INDESIT company

Model type:
WI82EX

Commercial code:
F030353

1180170 Exploded views

FIG. n1040305fig01

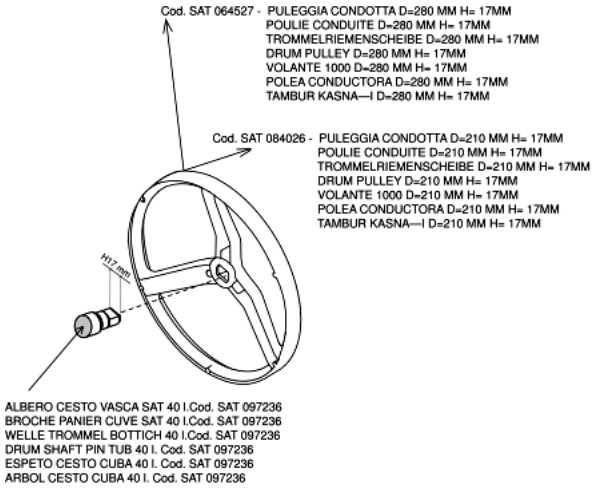
n1040305: Introduction of EVO on LB2000 washing machines produced at Teverola.

Since August 2003, the following modifications are gradually being made to the oscillating unit on 2000 range models produced in the Teverola factory:
Gradual use of the EVOII 40 litre plastic bowl (code 097236) which differs to the previous LB2000 version, for the following characteristics:
1) Assembled with basket and welded bowl lid;
2) Elimination of detergent recovery tube hole (where provided);
3) Diameter 30 cm opening instead of 28 cm;
The last two numbers of the Industrial Code (given on the rating plate) of the models relevant to this system will be 30 (e.g. 46268790030)
This modification has involved the use of a new table for the oscillating unit (1140240) in the documentation of the relevant models, and for the appliances the following parts have been used:

·Eeproms - The new software for the 40 litre EVO washing machines can also be used on premodification appliances; it is managed with the same Sat codes as the previous software, which is being immediately replaced as the new models enter into production.
·Pulleys - The use of a single 40 litre bowl assembly in Assistance involves management of the pulleys used in production (097268 and 097267) and also those required for creating the various combinations (see fig. n1040305fig.01):

Code 064527 - Pulley D=280mm H=17 mm;
Code 084026 - Pulley D=210mm H=17mm.

NB: From serial no. 31103.0001, all EVO appliances are equipped with a 40 litre bowl with H=15 mm drum cross shaft which will be managed with the same SAT code (097236) as the 40 litre bowl with H=17 mm shaft until stocks last.
To create the various combinations, the following pulleys are required:

Code 097268 - Pulley D=280mm H=15 mm;
Code 097267 - Pulley D=210mm H=15mm.
Exceptions to this are models W93UK (23330) and W103UK (23334) which are equipped with a 46 litre bowl; therefore if the bowl needs replacing code 096198 with 20 mm pulley cross shaft must be used.
In production, pulley code 064527 (diameter D= 280 mm and central hole H= 17mm) is used; therefore, when replacing the bowl, code 097269 (diameter D= 280 mm and central hole H= 20mm) must be used.
